**Oonoonba Urban Development Area - Stage 7
Abbott Street, Oonoonba**

Rail Noise Assessment Report

**PLANS AND DOCUMENTS
referred to in the PDA
DEVELOPMENT APPROVAL**

AMENDED IN RED

Figure 7: Recommended Acoustic Barrier

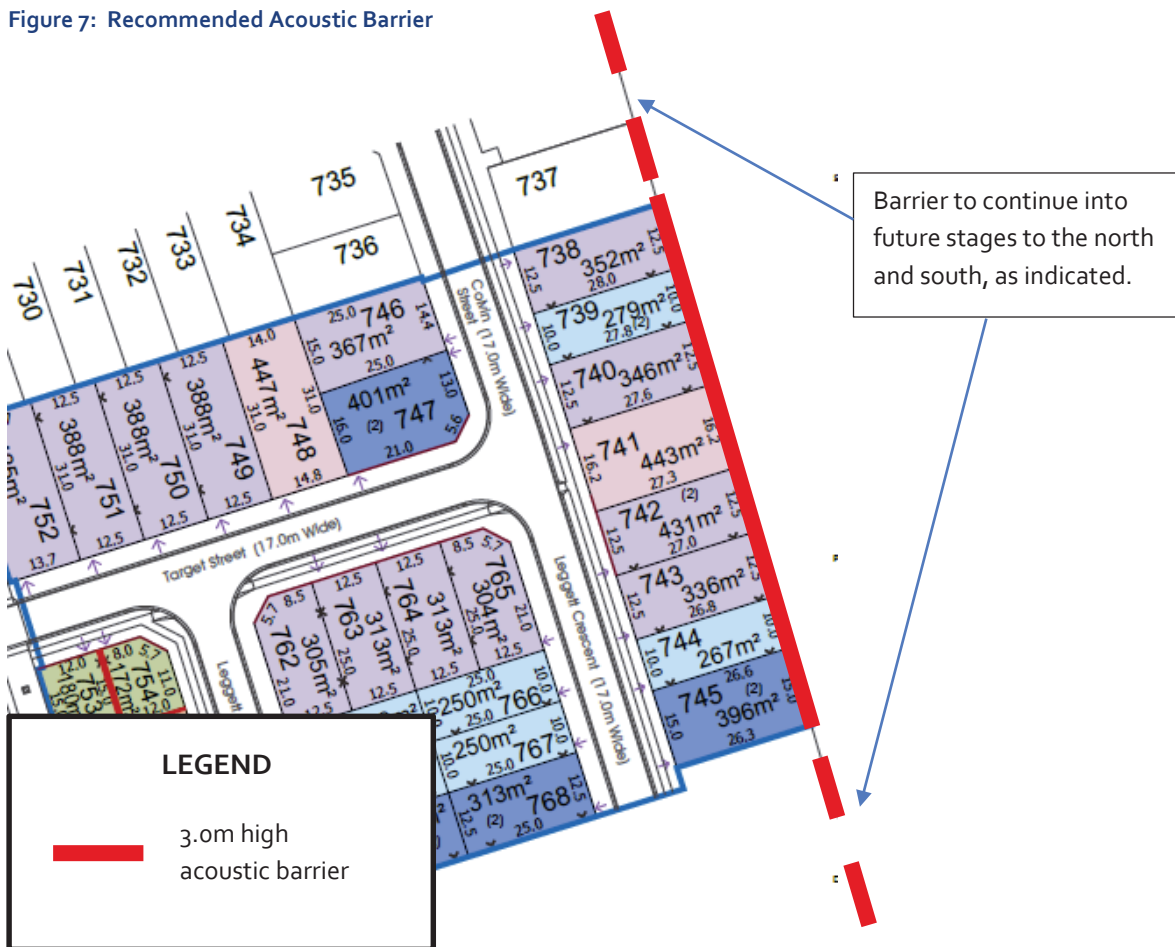
Acoustic barriers are recommended to reduce the QDC MP4.4 construction requirements for the ground floor level of dwellings. The location and extent of the acoustic barrier is shown in Figure 7. Barrier recommendations are as follows:

- The acoustic barrier should be minimum 3.0m high along the eastern site boundary. The recommendation assumes the barrier will continue along the same alignment into future stages to the north and to the south.
- The barrier height is relative to finished earthwork levels, or at a minimum RL 3.9m.
- The barrier should be constructed of a material with a surface density of at least 15kg/m² and be constructed in accordance with Queensland Rail *Civil Engineering Technical Requirement – CIVIL-SR – Design of noise barriers adjacent to railways*.
- No gaps or holes should be evident in the fence construction.
